1. ALL WALL BENCHTOPS SHALL BE 30" DEEP INCLUDING BACK SPLASH (UNLESS OTHERWISE NOTED).
2. ALL ISLAND BENCHTOPS SHALL BE 60" DEEP (UNLESS OTHERWISE NOTED). RFI-52

LMC SCIENCE 313-023-T12.01-0-00.00
drawing no:
LF1-01

Los Medanos College
4CD Proj.# : L-S65-B-23-SC
Science Building

LMC SCIENCE 313-023-T12.01-0-00.00
drawing no:
LF1-02

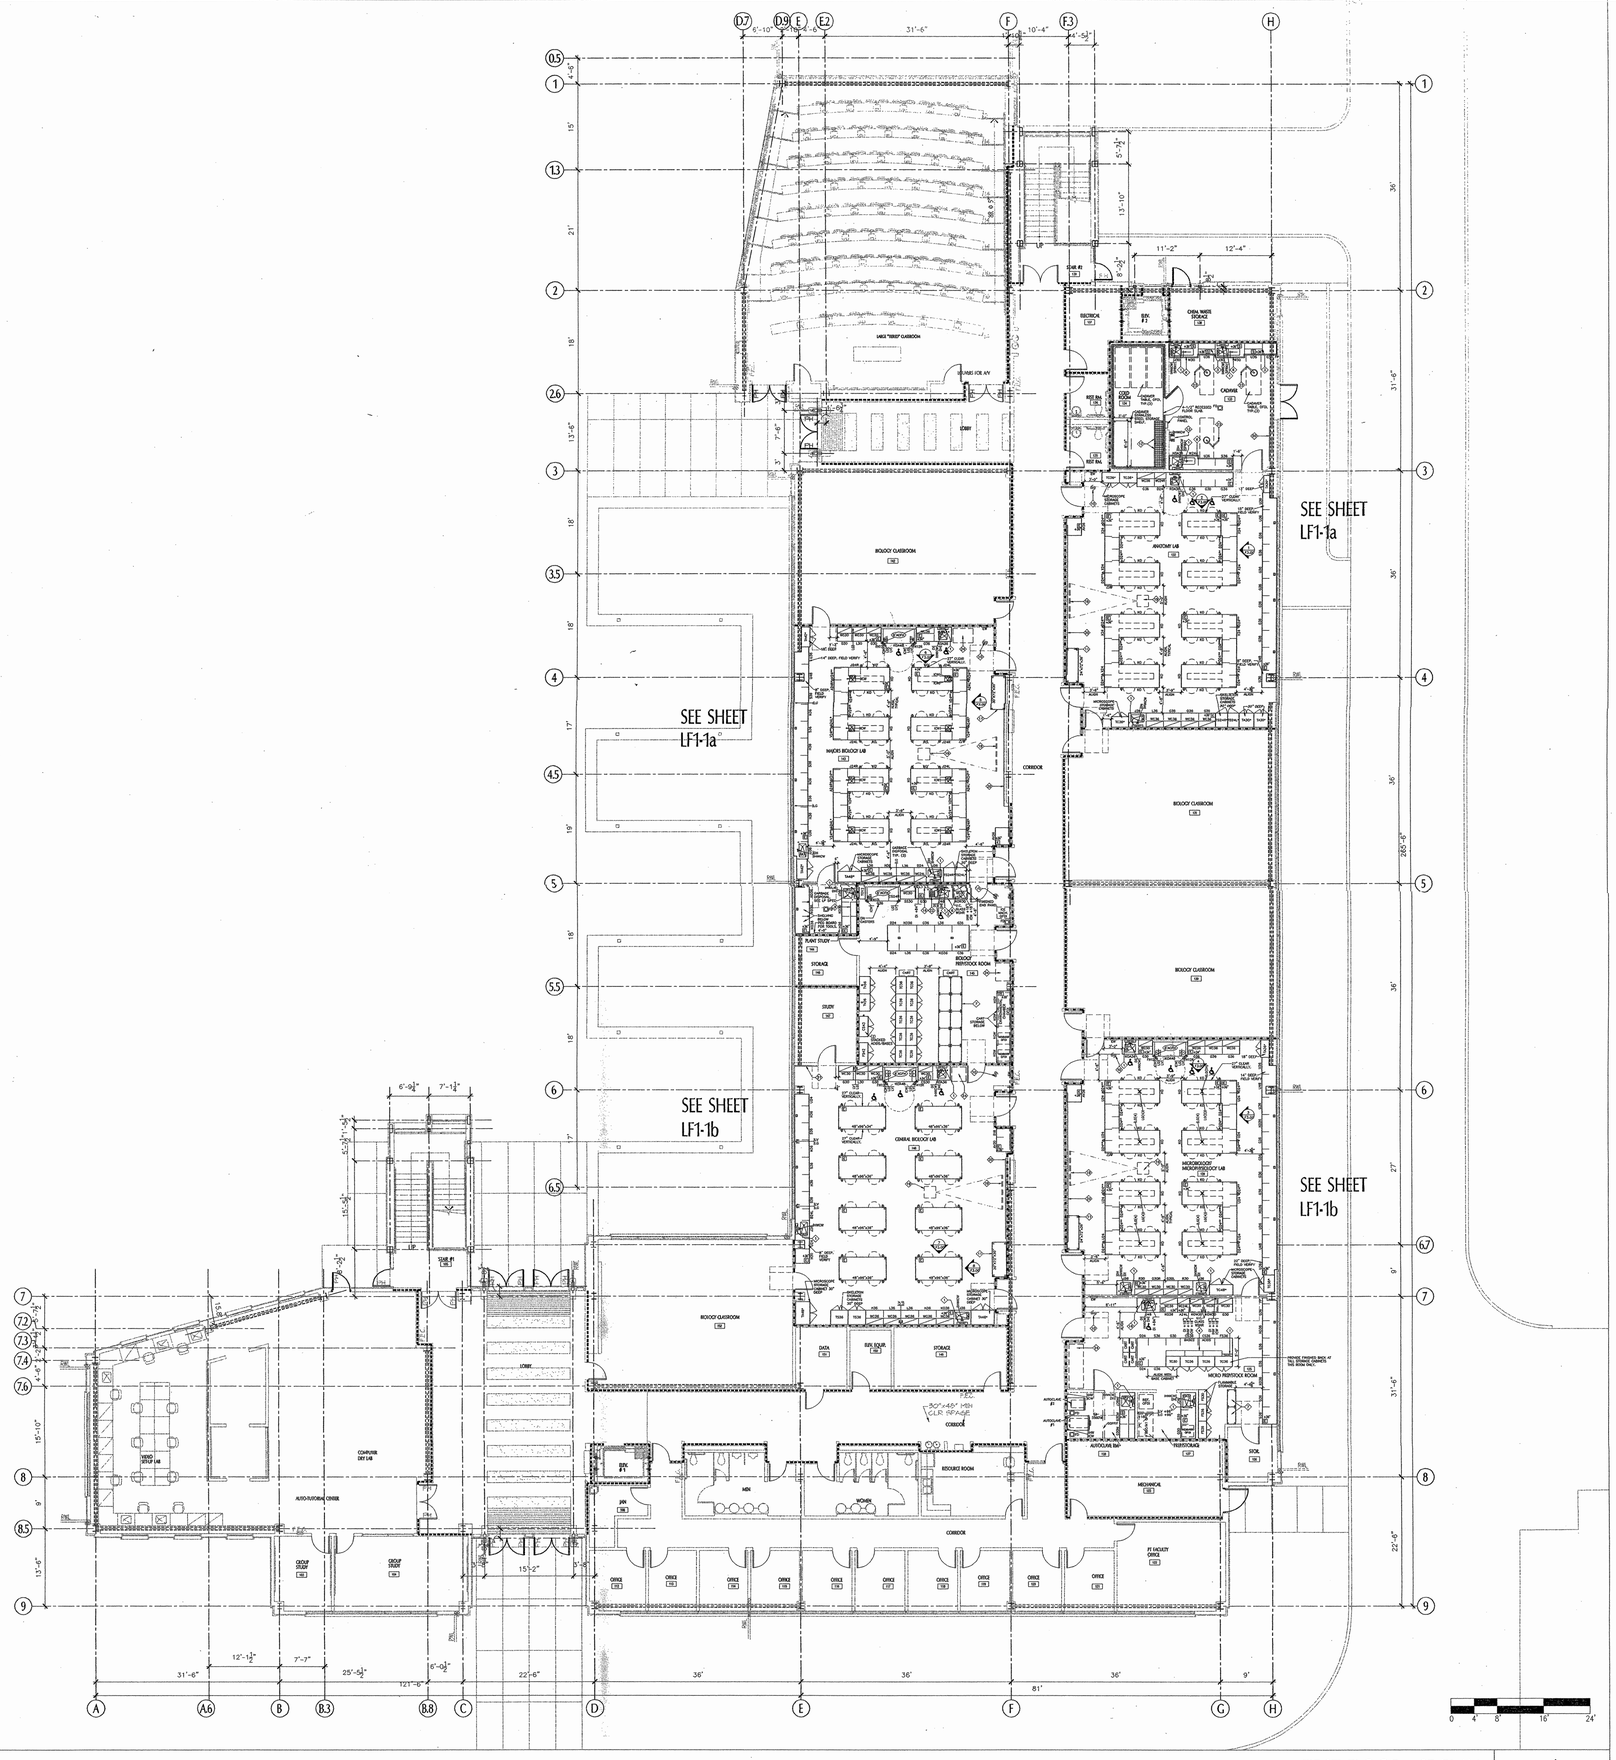
In review of submittal 43, lab casework, a garbage disposal was added on sheet 1 (north wall of Majors Biology Lab 143). Also, on sheet 14 (north wall of Biology Prep/stock room 145) a 12" deep sink is shown. On sheet 55 (north wall of Micro Prep/stock room 125) a 12" deep sink is shown. Each of these three locations is called out as knee space panels for ADA access but the garbage disposal and deep sinks would seem to conflict with required ADA clearances. Please advise.

No garbage disposal required in Room 135 and Room 145 per Laboratory Furnishings Construction Documents.
Garbage disposal located on north wall of Lab 143 (ADA sink location) should fit behind the ADA access panel (Detail B4/LF4.01). Refer to response on RFI #306 for similar installation.

LMC SCIENCE 313-023-T12.01-0-00.00
drawing no:
LF2-1b

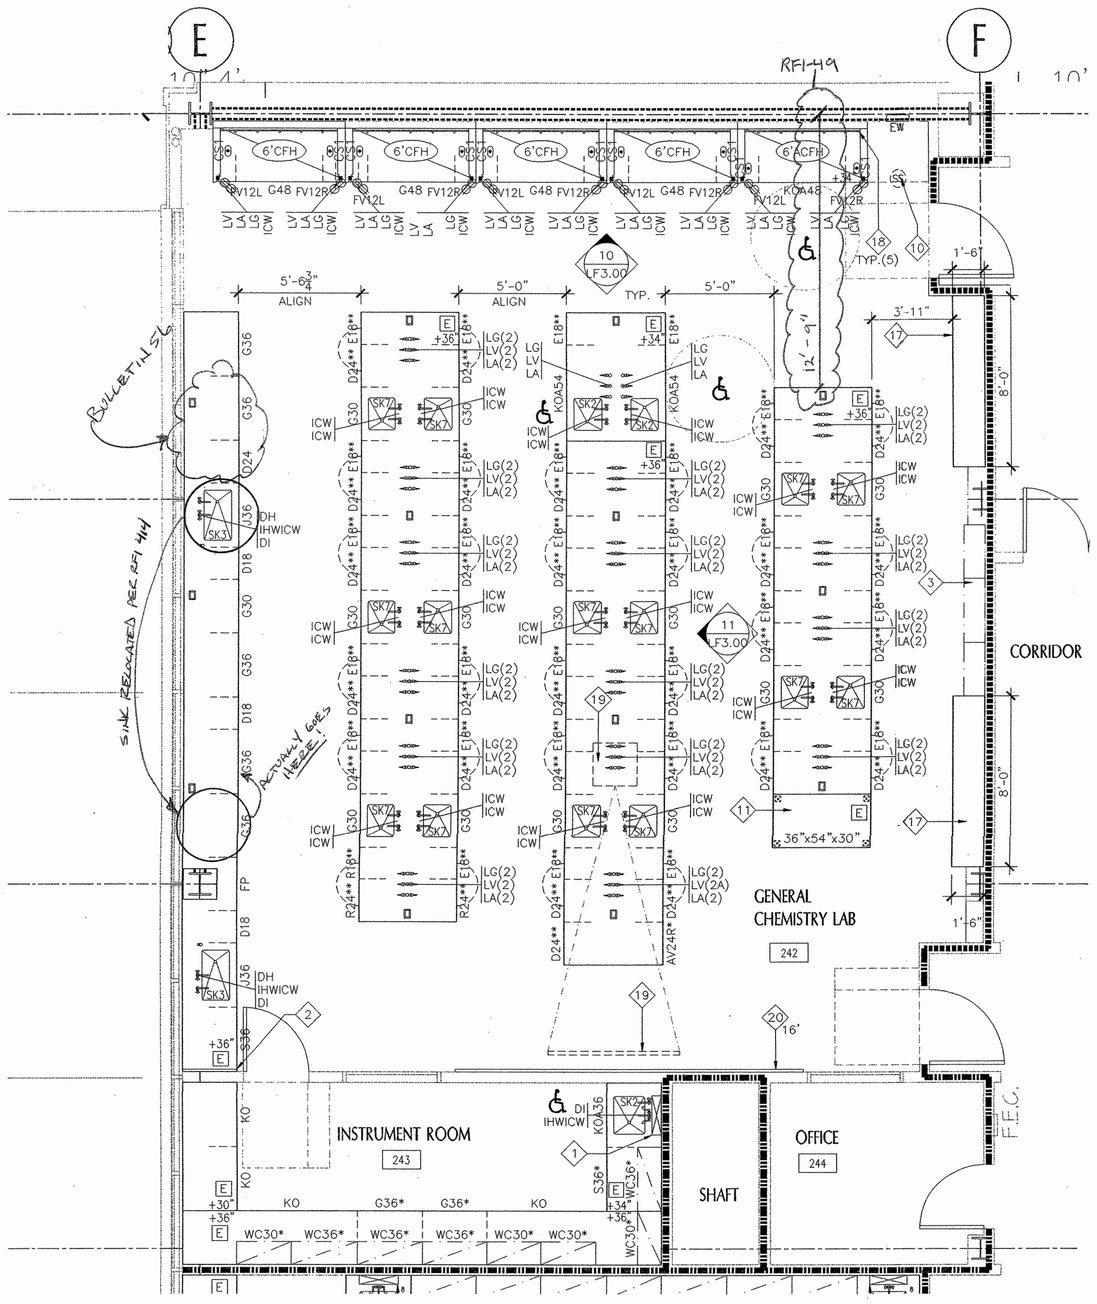
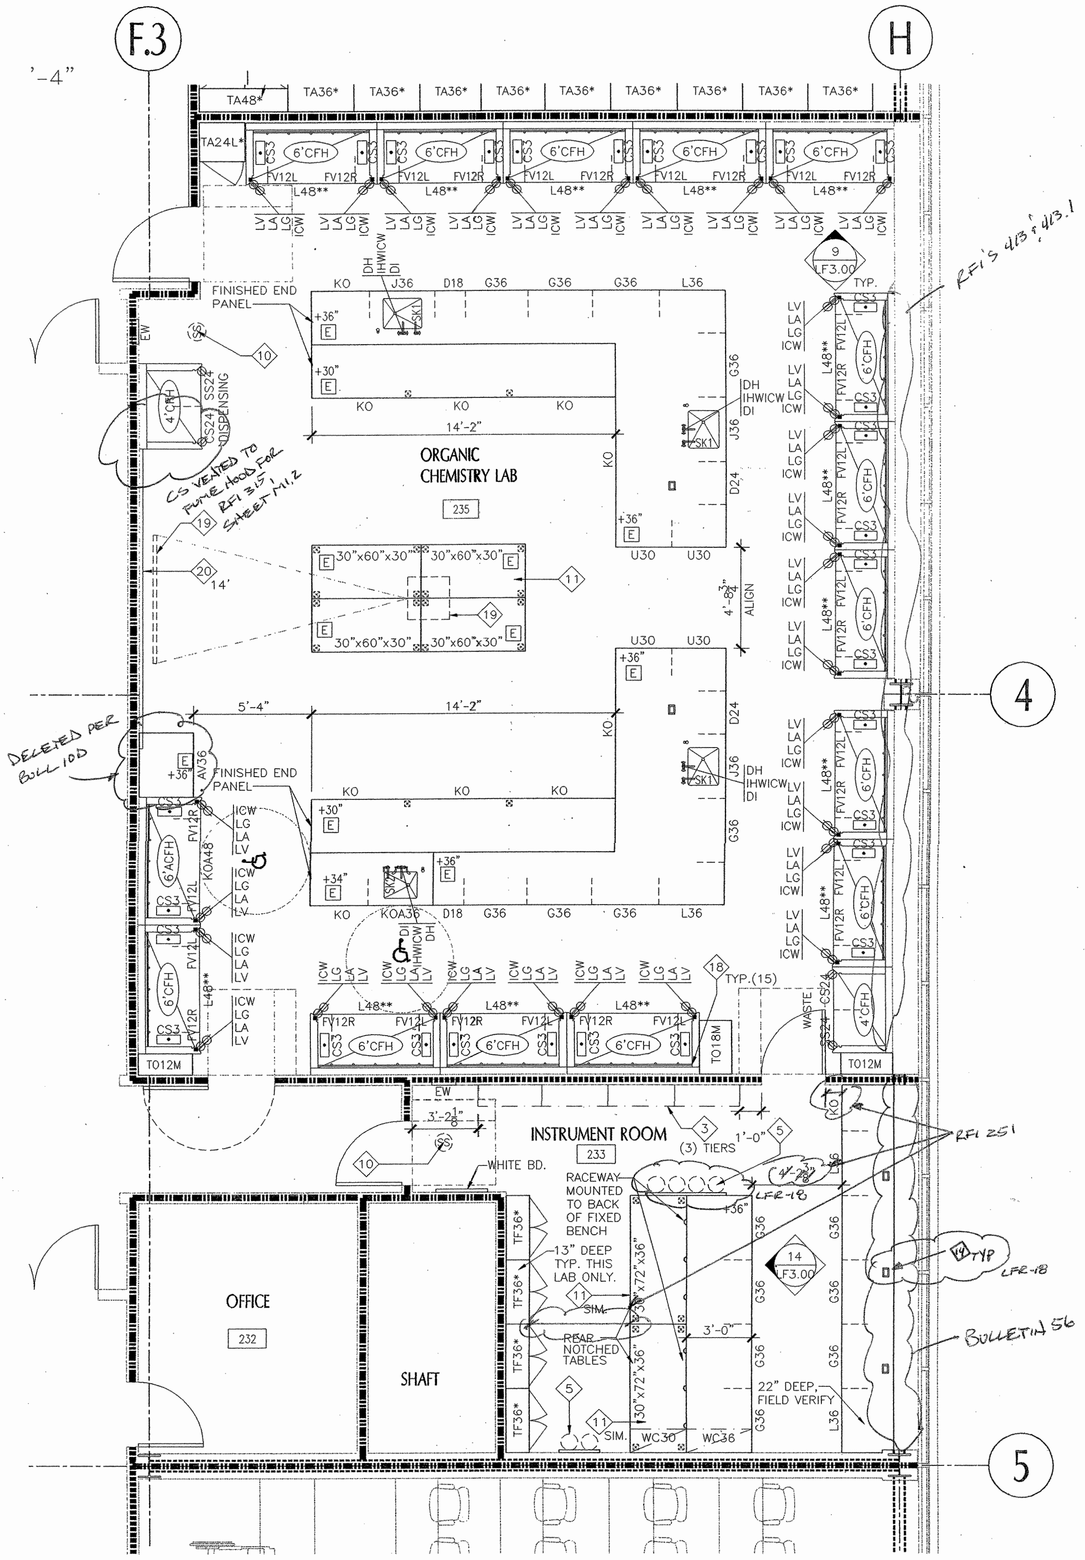
To: tBP/Architecture, 1000 Burnett Ave, Suite 140, Concord, CA 94520
Project: LOS MEDANOS COLLEGE SCIENCE BUILDING, Contra Costa Community College District
Attn: Celia Chiang, Tom Beckett
Fax: 925-246-6495
tBP p/n: 20247.00
Subj.: Fume hood anchorage west wall of room 235
RFI No: 413
Reference (dwg, spec.): 2/LF2-1B, LF-4.0
Subcontractor RFI: DDI 5
Reply Requested By: 11/3/06

Please see the following response items:
1. The second floor condition per 4/A6-1 indicates an approx 8' wall that aligns with the top of mullion at exterior window.
2. Per details 2,3 & 6/LF4.04 the fume hoods have been shown to anchor to the base cabinets and base cabinets anchored to the floor. These connections are the primary gravity and seismic anchor points. Wall anchorages to be provided as secondary measures. Please coordinate with DDI and current fume hood submittals.
3. The east side 8' wall shown detail 4/A6-1 and 4/4.05 is to continue full length of room. Inside face of stud flushes with inside face of brace frame, therefore do not see conflict with fume hood at north side per LF2-1b.

ANCHORAGE DETAIL - CASEWORK 1-1/2"=1'-0" (4)

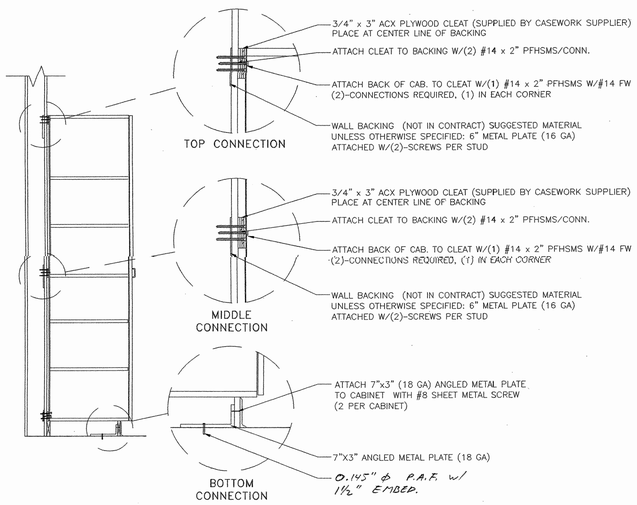
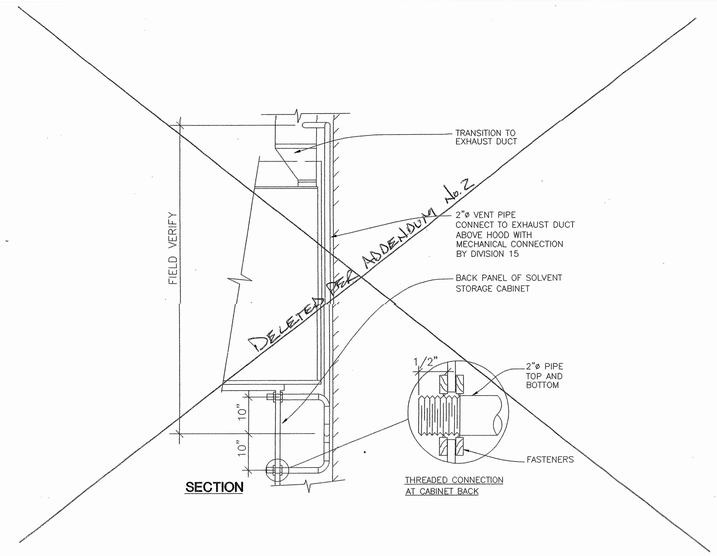
Please note the attached Dow Diversified RFI No. 9 regarding casework anchorage details. Page LF1-02 refers to details 4 and 5 on LF 4.03 for anchorage; however there is another detail on LF4.00. Please advise as to which detail to use.

REQUEST:
There appears to be an anchorage detail conflict. LF1-02 (Backing Heights and Anchorage) refers to details 4 & 5 on LF4.03 for anchorage. However, there is another detail on LF4.00.

It appears that the main difference is one shows a Unistrut assembly behind the casework with no anchorage at the toe kicks. The other detail on LF4.03 shows overlapping angles behind the casework with anchorage at the toe kicks also.

If the detail on LF4.00 is chosen, does that mean that no toe kick anchorage is required?

SUGGESTION:
DOI would like to suggest that we use the anchorage detail on LF4.03. The overlapping angles provide adequate anchorage at the top while also allowing for horizontal adjustments in the field.

The detail on LF4.03 is also very close to what DOI normally does. We can and certainly have used the detail on LF4.00 but would prefer to stick with our typical installation if possible.

USE DETAILS 4 & 5/LF4.03 PER RFI 445

LMC SCIENCE 313-023-T12.01-0-00.00
drawing no:
LP2-1b

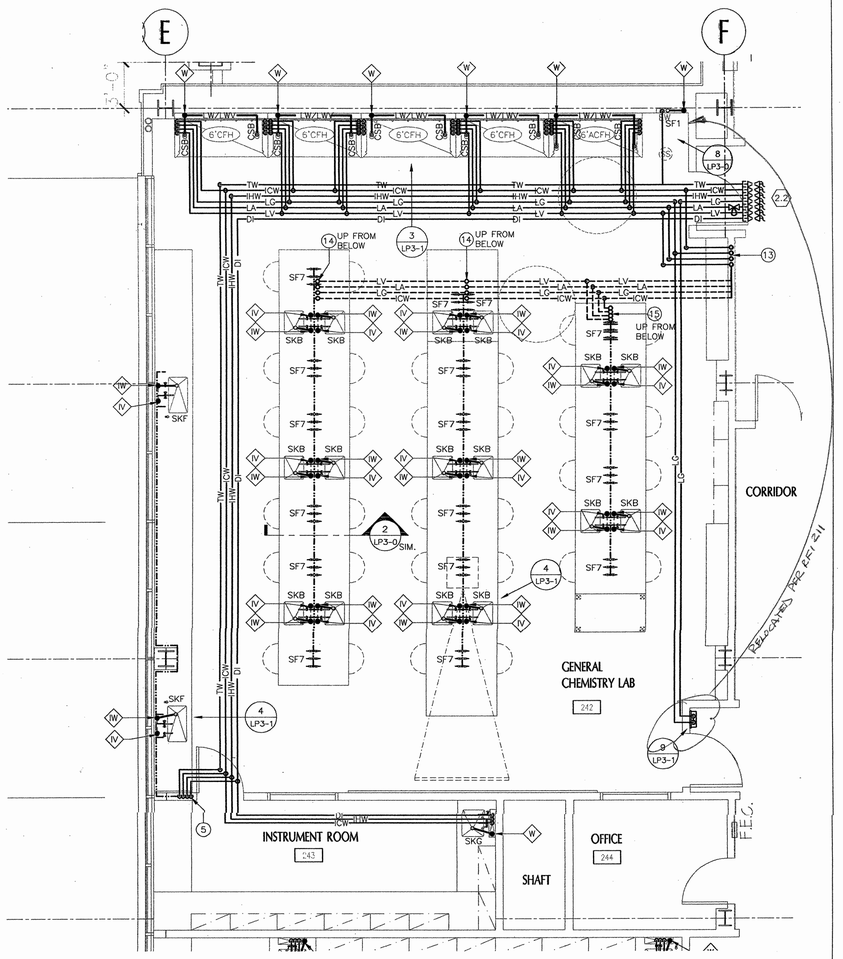
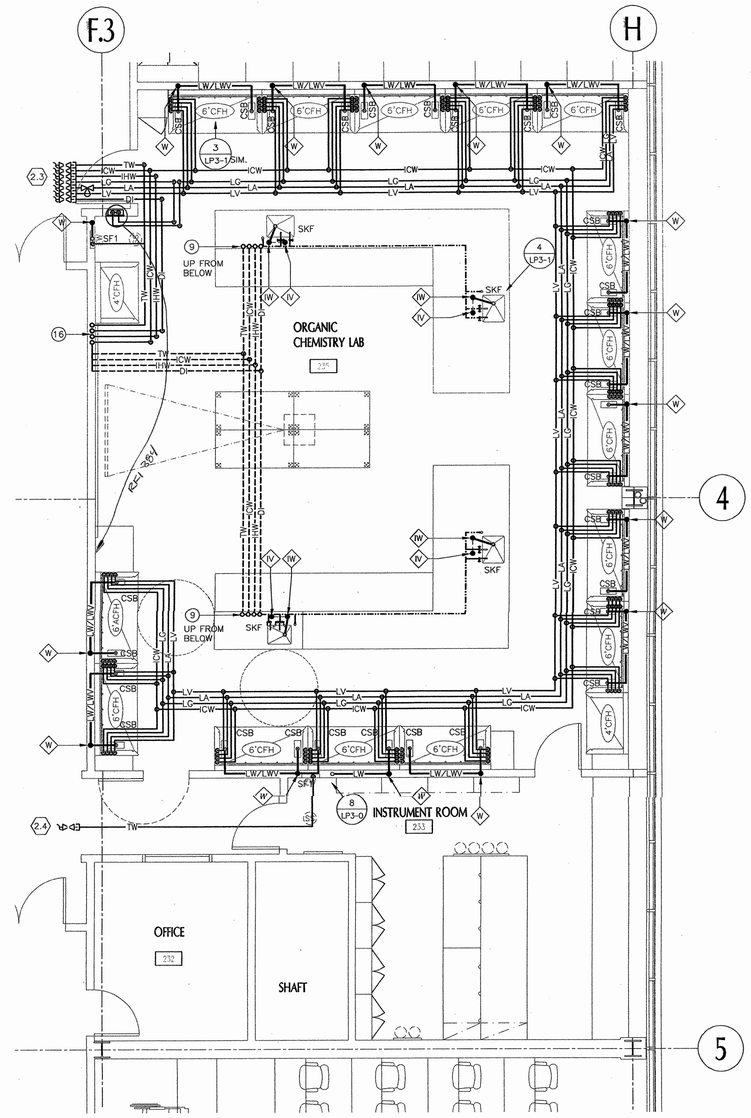
On sheet LP2-1b, the Lab Gas Shut-off Valve is shown outside of General Chemistry Lab 242 near door 245. Dowdle would like to install this valve near door 245 (also outside of General Chemistry Lab 242). Please advise if this is acceptable.

Per sheet LE2-1b, and electrical panel is located in the above wall near the corridor entry to room 235. This panel is the same depth as the wall. Per sheet LP2-1b, there is a gas shut-off valve in 235, which is the lab/lecture room. However, it cannot be installed in this location due to the presence of the electrical panel. There is an eye wash in the adjoining wall, preventing installation of the valve there. Please advise.

NOTE: NO PIPING FROM CORRIDOR DIRECTLY TO VALVE
